22 June 2026

Change Application to PDA Approval for 83, 87, 93, 93A, 97, 97A, 101, 101A, 105, 105A, 109 and 109A Albert Street; and 100, 100A and 104 Mary Street, Brisbane City (EDQ Ref.: DEV2023/1374/3)

LTR_101 Albert St., Brisbane City_Change Application_ 260622

Figure 3 – Comparison of Approved & Proposed Basement Layout

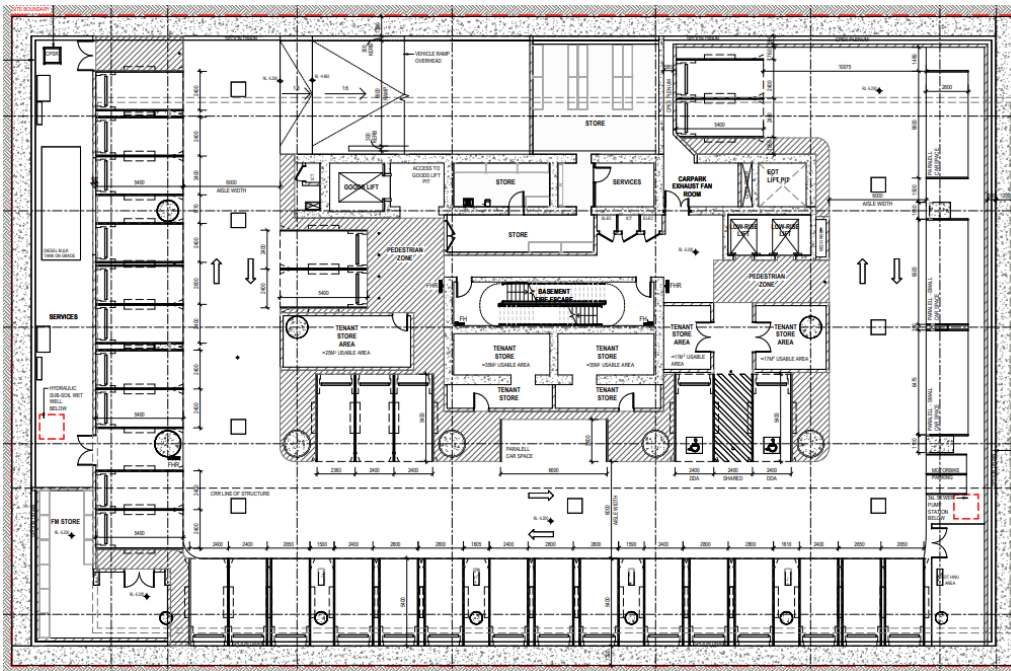
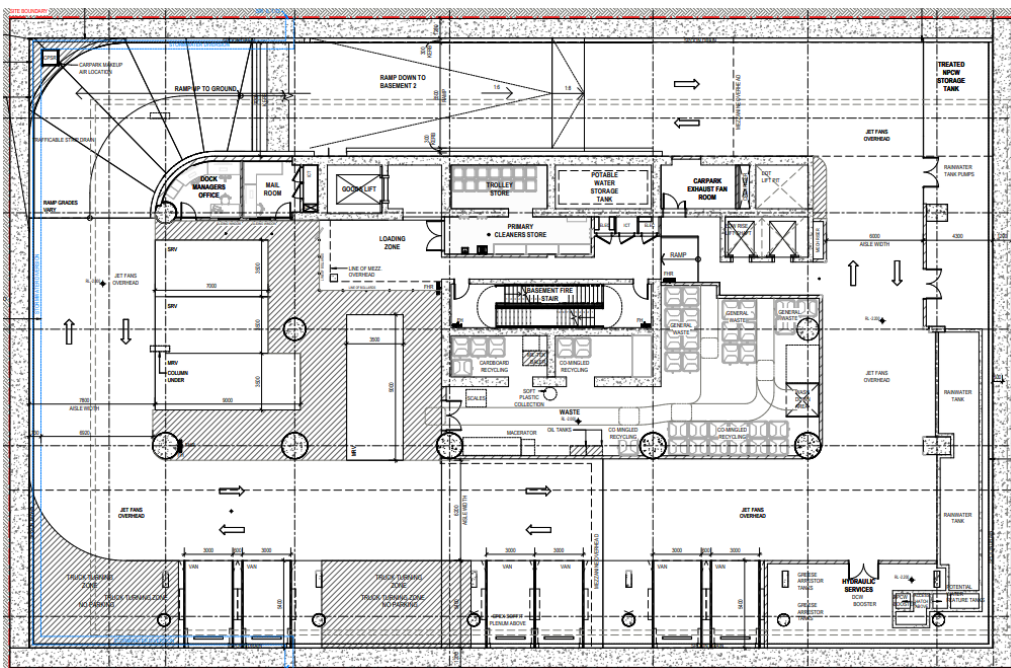
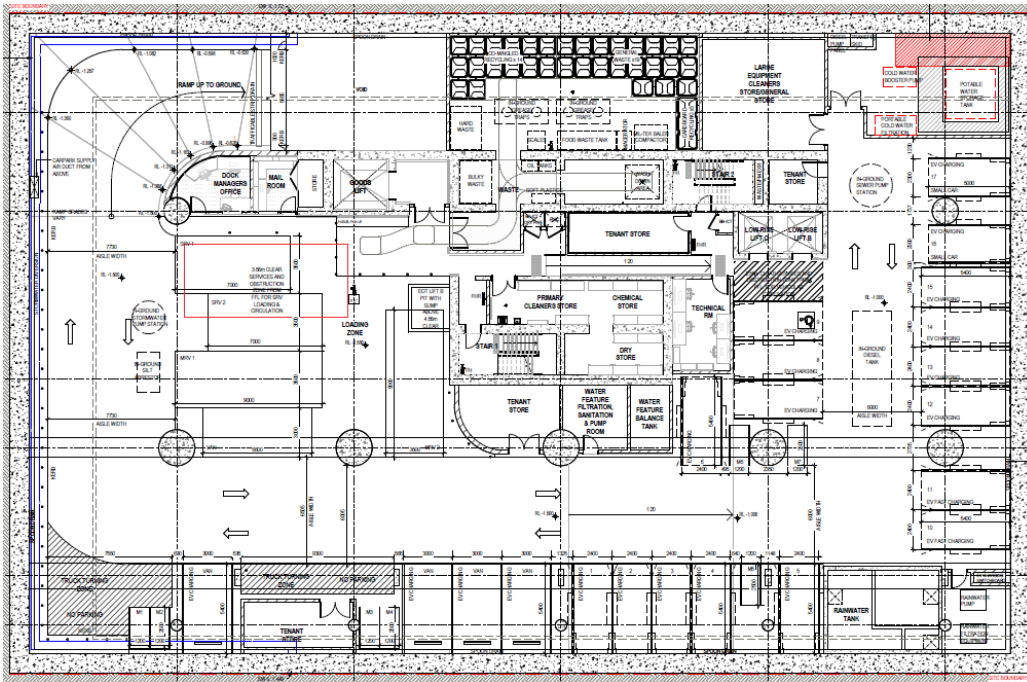
The proposed amendments refine the approved basement arrangement by removing Basement Level 2 and consolidating the below-ground car parking provision within the remaining basement level. This change simplifies the basement configuration and reduces the extent of below-ground excavation required to deliver the development.

The revised arrangement results in a reduction to the approved car parking provision from 38 car spaces to 17 car spaces, including two (2) PWD spaces and two (2) small car spaces. Vehicle access will continue to be provided from Mary Street, consistent with the approved development.

Figure 3 provides a comparison between the approved and proposed basement arrangement, highlighting the removal of Basement Level 2 and the revised car parking layout.

Figure 4 – Comparison of Approved & Proposed EOT Layout (Marked in green)

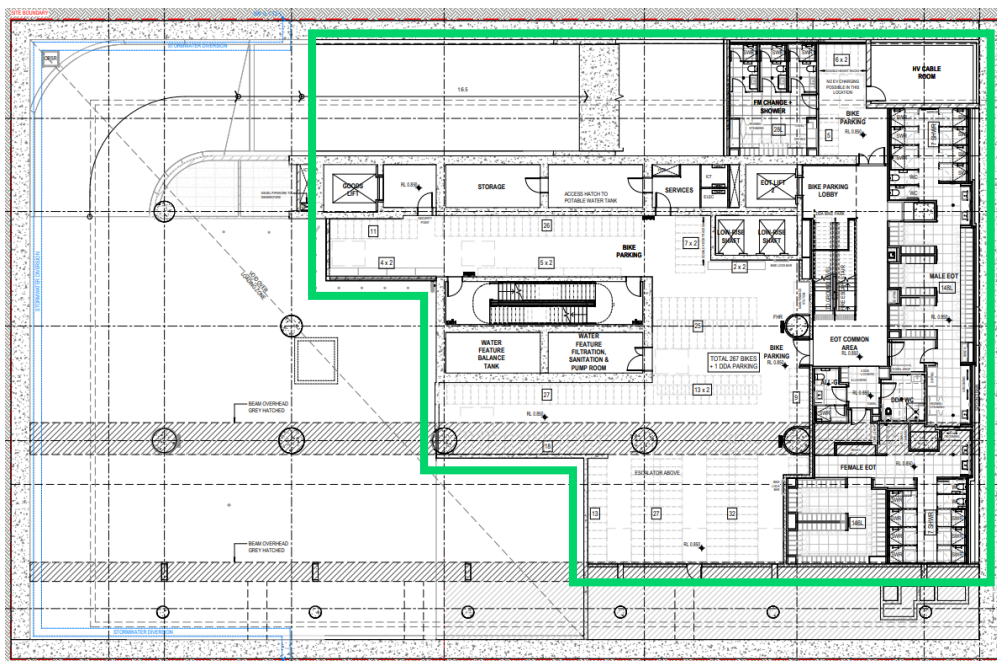
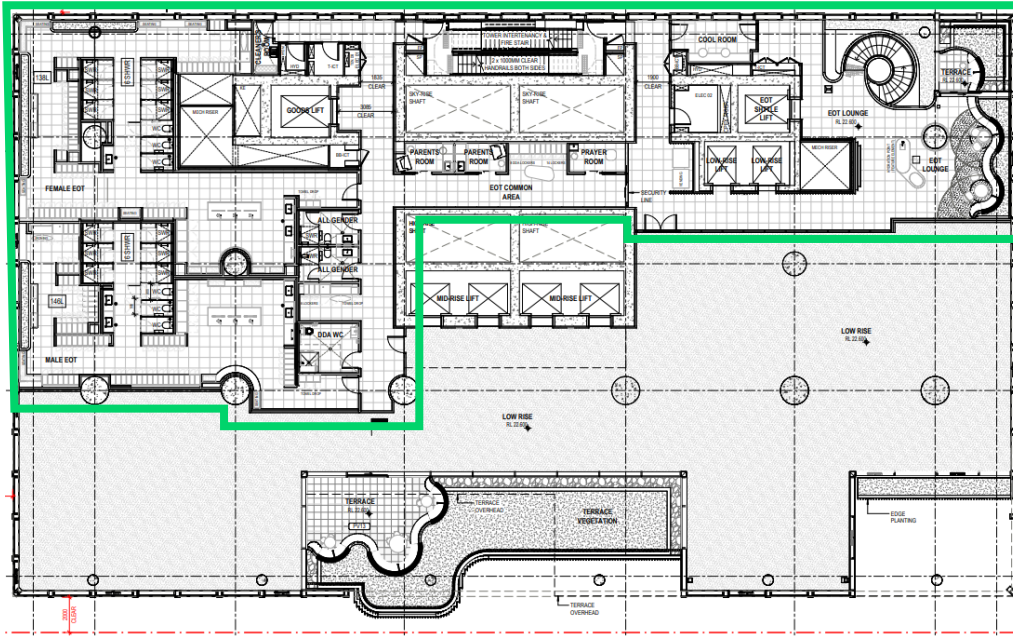
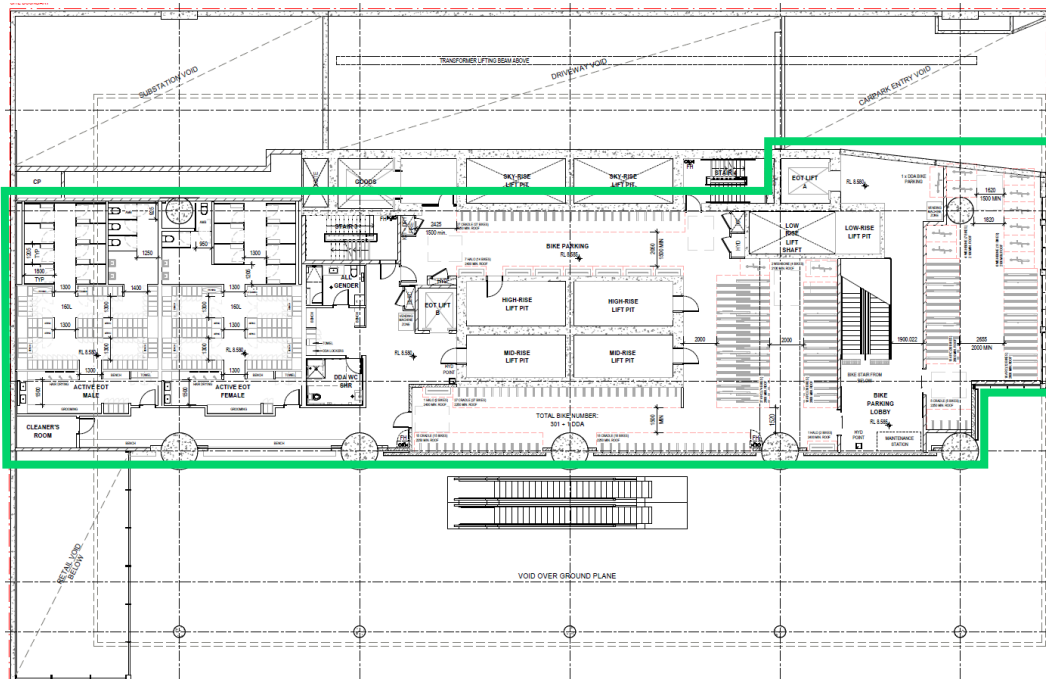
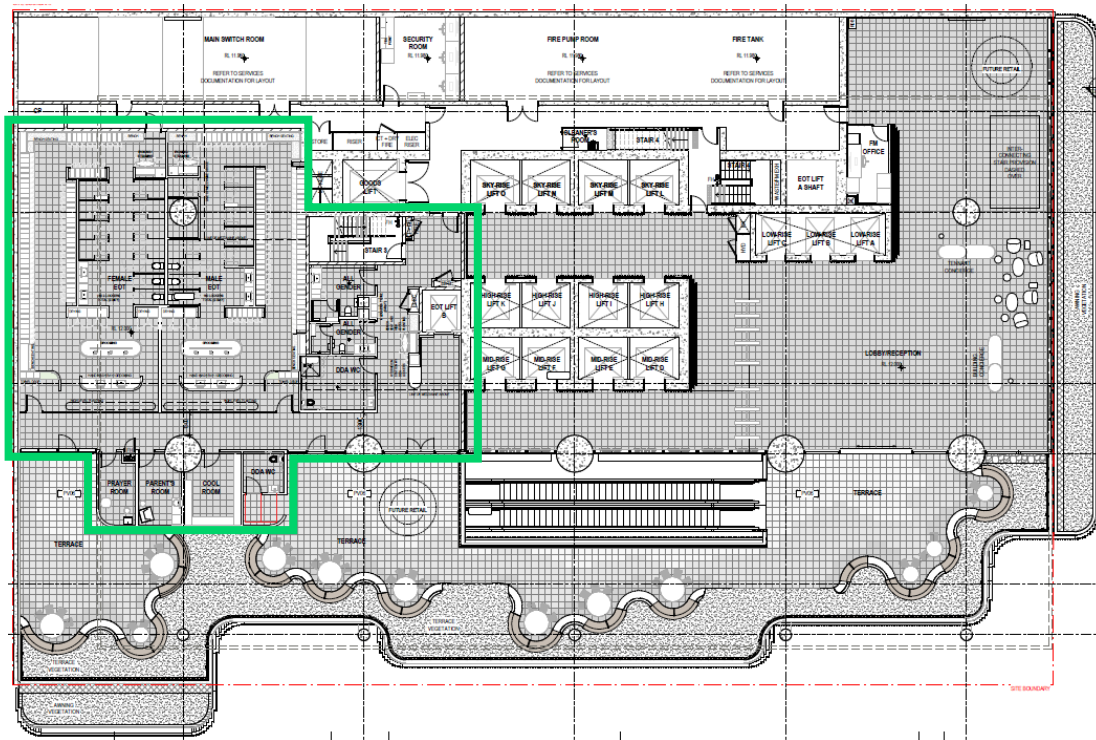
The approved active EOT arrangement is proposed to be relocated from the lower ground level to the new Upper Ground level. This amended arrangement allows the end-of-trip facilities to be consolidated within a more efficient lower-level layout, while maintaining convenient access for cyclists and building occupants.

The revised design maintains a dedicated EOT facility arrangement, now located within the Upper Ground and Level 1. This includes the relocation of the wellness EOT facilities from Level 3 to Level 1, supporting the ongoing operation of the development as a high-density commercial tower and maintaining a strong active transport focus within the CBD context.

- bicycle parking increasing from 268 spaces to 302 spaces;
- showers increasing from 31 to 33; and
- lockers increasing from 606 to 628.

Picture 11 – Proposed Level 01 (Office Lobby)

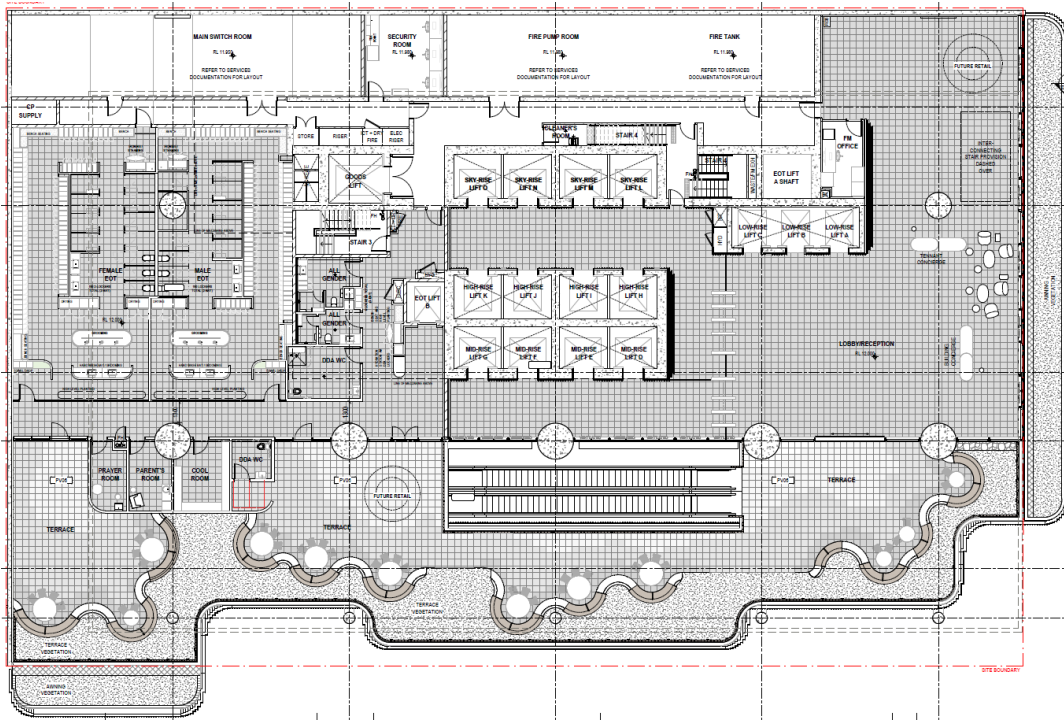
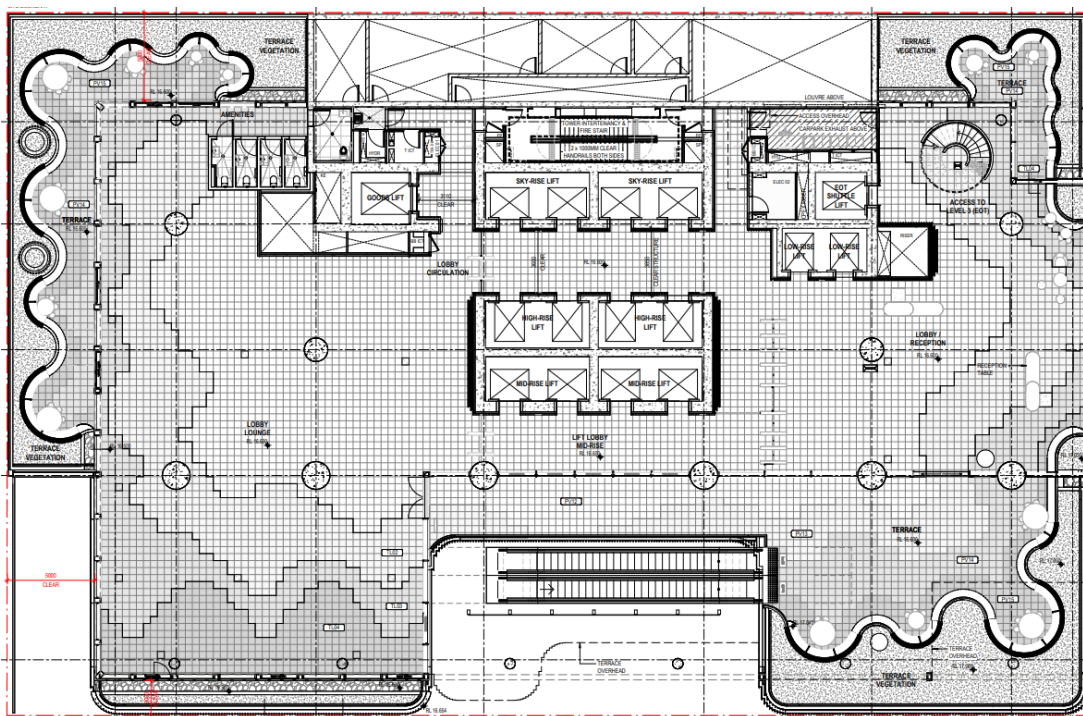
Level 01 has been reconfigured to accommodate the main building lobby, which has been relocated from Level 02 to Level 01. This change brings the lobby closer to the ground plane and provides a clearer, more

Figure 6 – Comparison of Approved and Proposed Landscaping

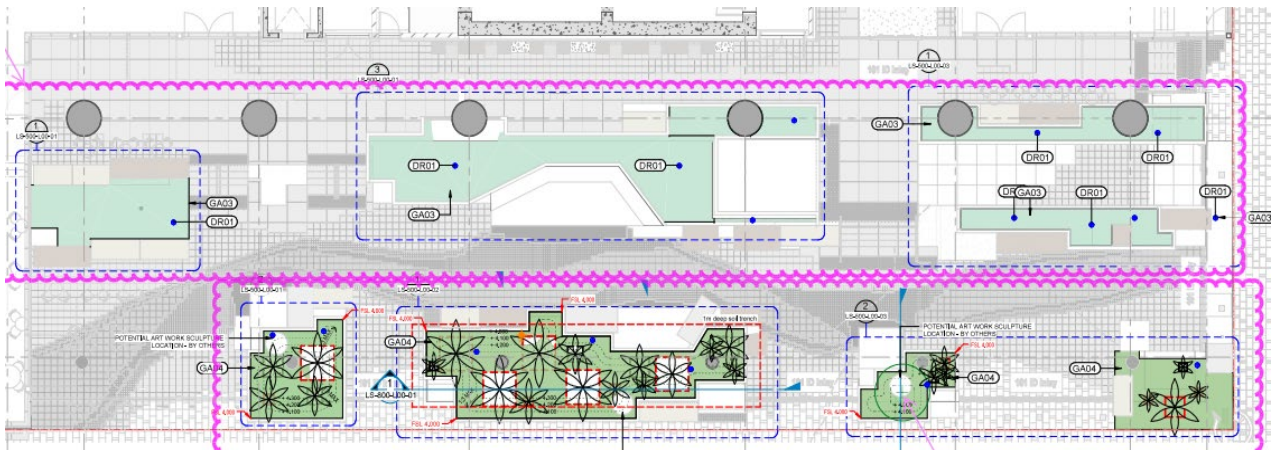
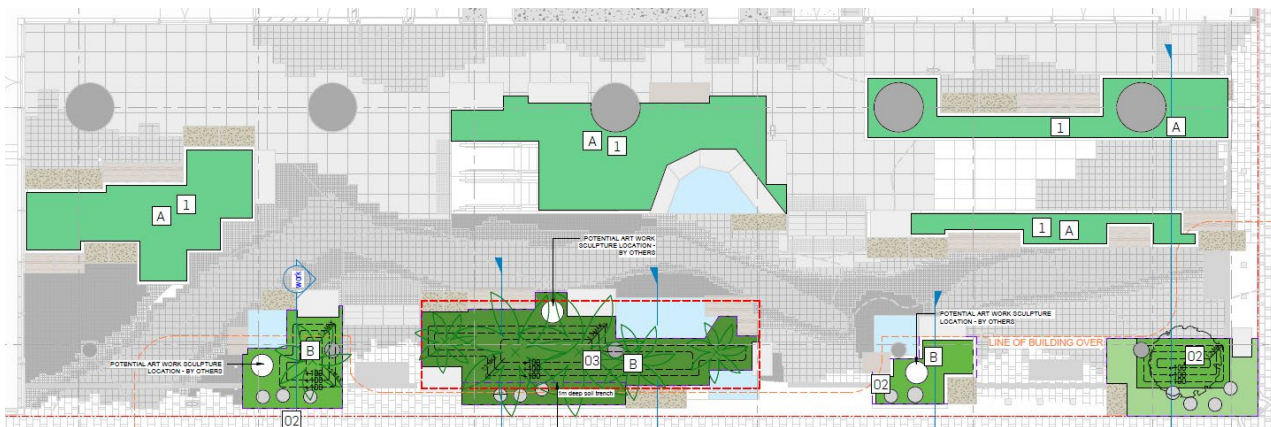
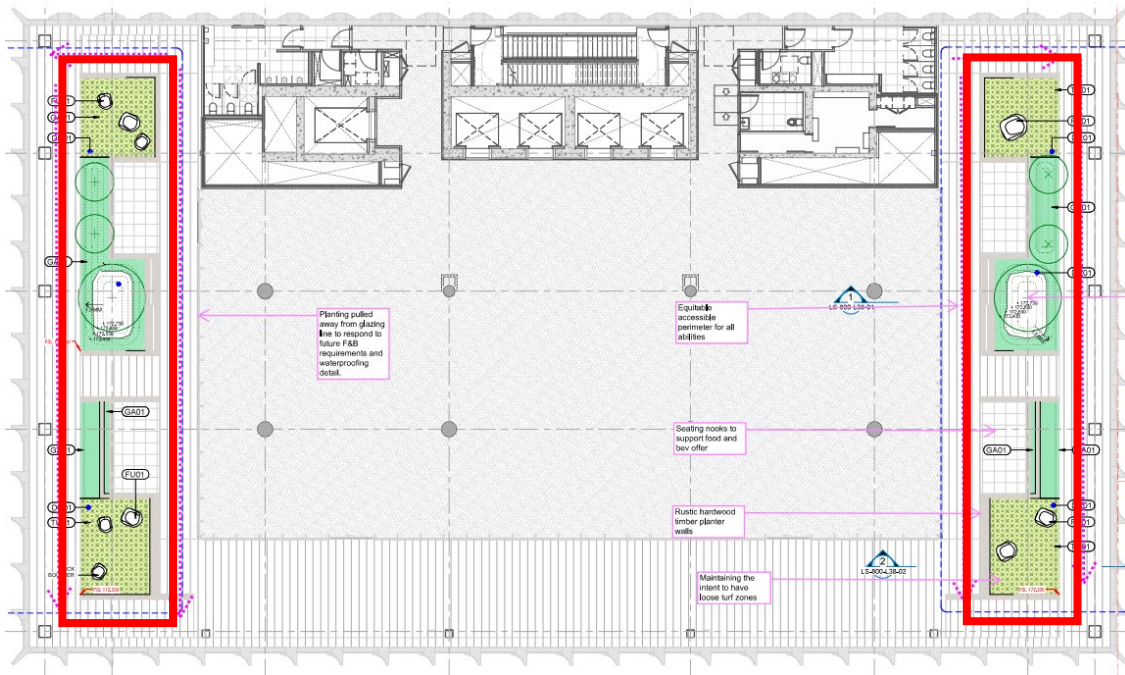
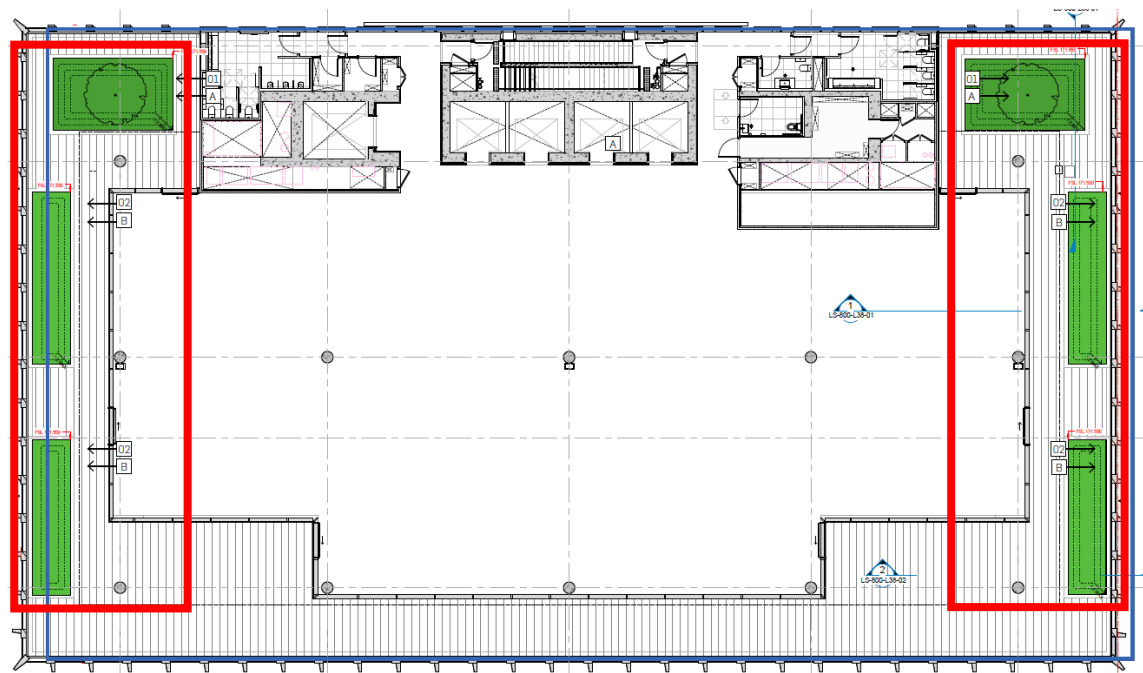
- removal of the central water feature (water wall) at the ground floor;
- reconfiguration of the water features and planting zone at the ground floor;
- minor changes to external seating areas and visitor bicycle parking;
- revision to the Level 01 plaza arrangement, including bringing the plaza closer to the front site boundary;
- reduction and reconfiguration of selected terrace and landscaped areas across the lower and upper activated levels; and
- amendments to the rooftop terrace and landscape areas as part of the updated upper-level arrangement.

At the ground floor and Level 01, the proposed amendments continue to provide meaningful landscape and public realm outcomes. In some areas, the external terrace spaces have been extended forward, strengthening the relationship between the building and the adjoining frontage. The ground plane remains the most publicly visible and accessible component of the landscape strategy and continues to support activation, permeability and visual amenity at the pedestrian level.

The amended design also rationalises landscaping on Levels 5 to 9 and at the rooftop. While these areas formed part of the approved landscape strategy, the changes respond to tenant requirements for floor consistency, additional office floor space and a more practical delivery outcome. The proposed amendments therefore recalibrate the extent of upper-level landscaping to better align with the functional requirements of the building, while retaining the overall landscape and public realm principles that underpin the approved design.
